Response Form Project Number S17-0004 McDonald's

DATE:	July 12, 2017
TO:	City of Denton, Planning & Zoning Commission
RE:	Objection to Specific Use Permit Case S17-0004

S17-0004 Notification Map

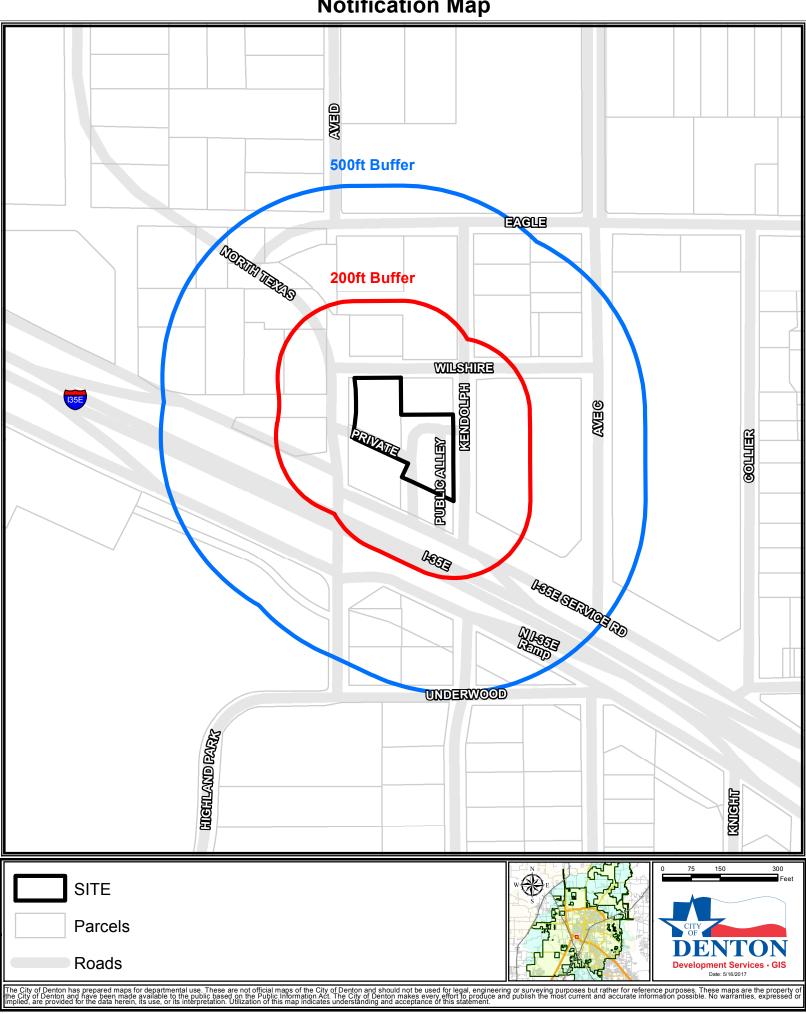
Physical Address of Property within 200 Feet: See Attached list of nine affected UNT
